Ross Township Board of Commissioners
Combined Committee/Business Meeting
1000 Ross Municipal Drive
Pittsburgh, PA 15237
January 20, 2020
7:00 p.m.

SUBJECT: Grading Plan for North Side Cemetery – Phase 2
Grading Plan G-121

Re: Response to Comments
3rd Technical Review – Revised Grading Permit Application
Grading Plan for North Side Cemetery – Phase 2
Ross Township, Pennsylvania

SHEET NO.
C-501

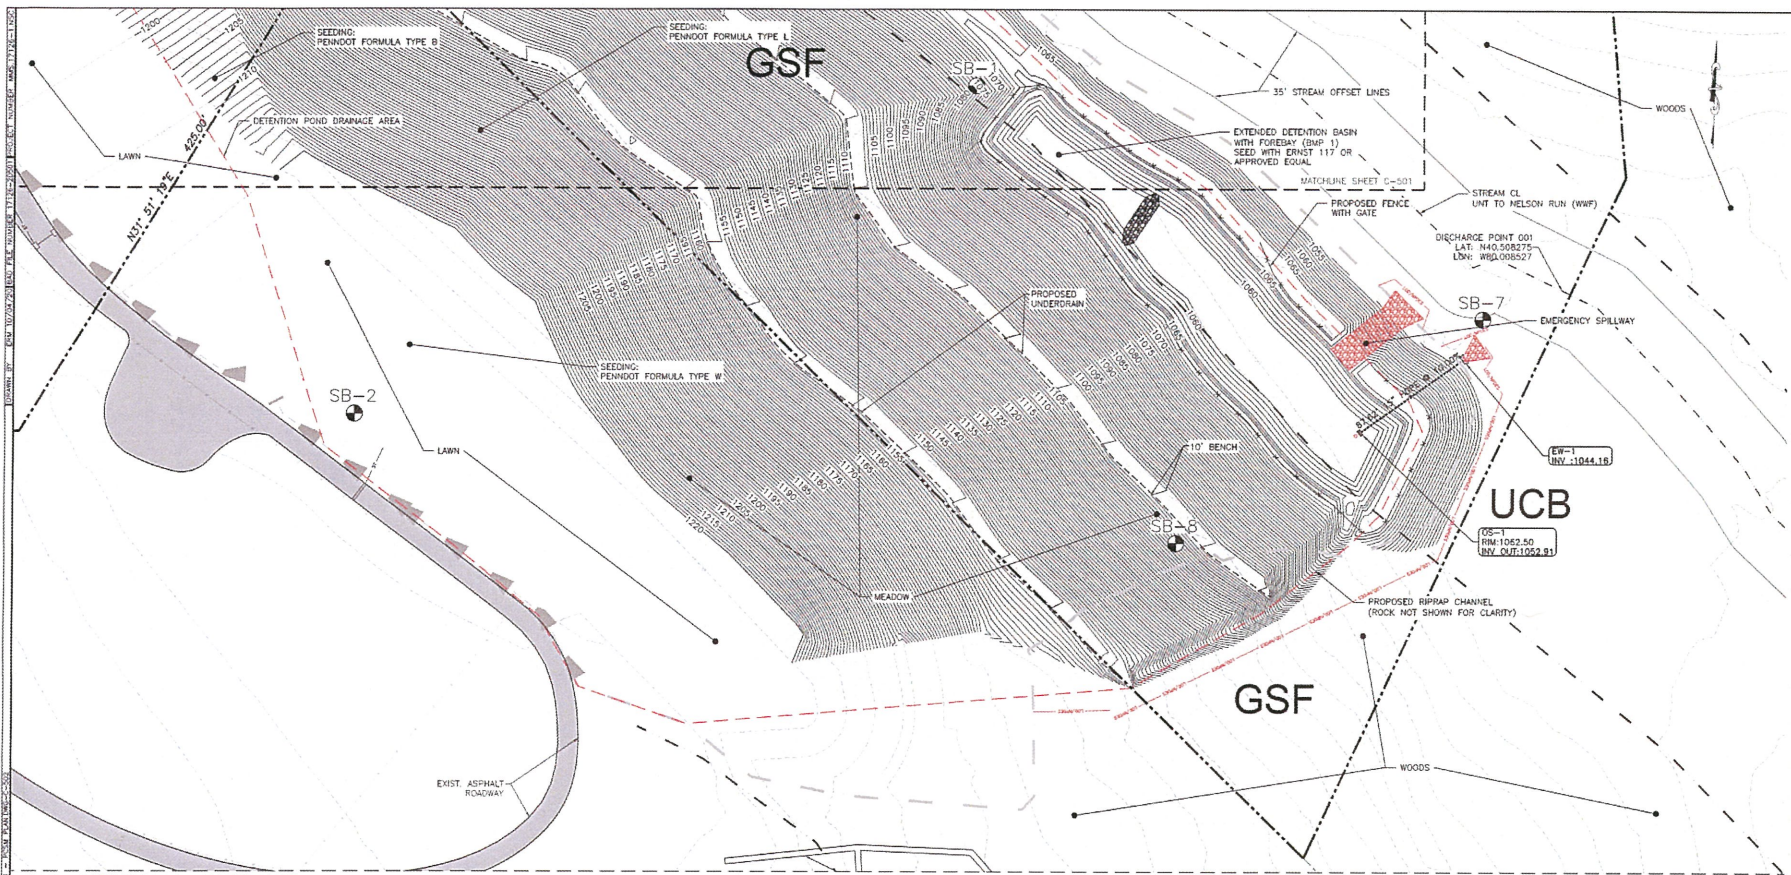
Comment 2: A detail for PCSM outlet structure is required.

Response: A PCSM Outlet Structure Detail has been added to sheet C-503.

BENCH DRAINAGE DETAIL
N.T.S.

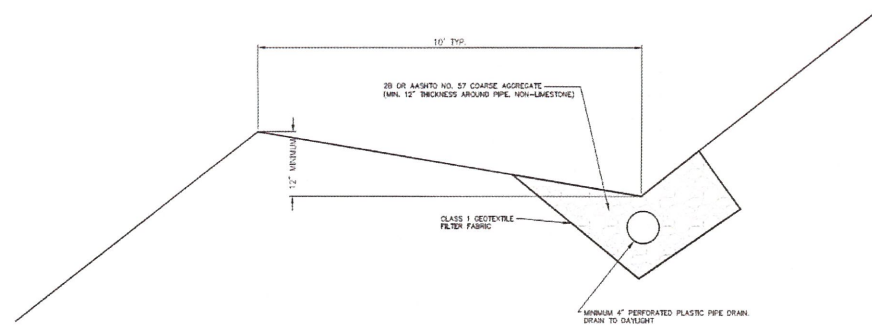
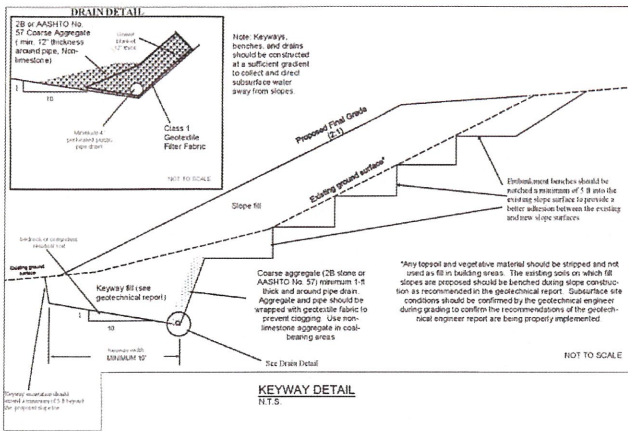
Comment 4: Flow from proposed bench underdrains will not reach sediment basin in E&S or PCSM phase. A revised outlet location or channel will be required to direct flow to the pond.

Response: A channel has been added to the edge of the proposed grading to ensure the flow from proposed bench underdrains will reach the sediment basin. Calculations for this channel are included with the E&S Module.

C-405B

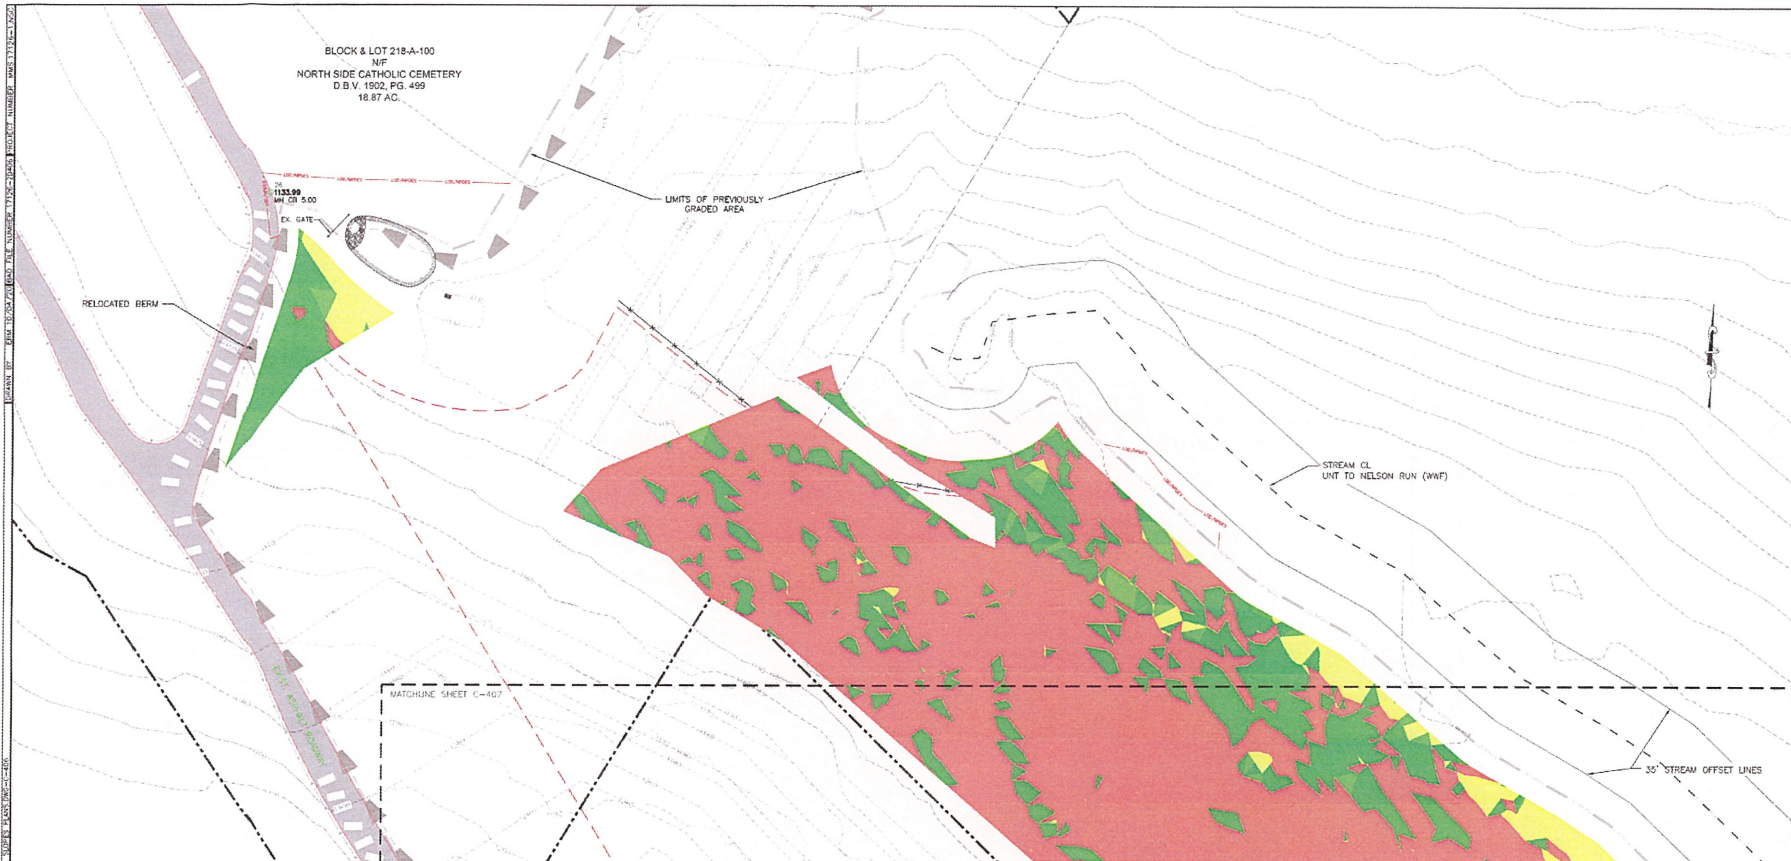
Comment 1: Slope Map: On the steep slopes plan, provide the ordinance requirements versus what the plan is providing. There should be a column for overall property area, disturbed area, and %. The requested modification does not line up with the slope maps provided.

Response: Sheet C-409 has been provided to include these values.
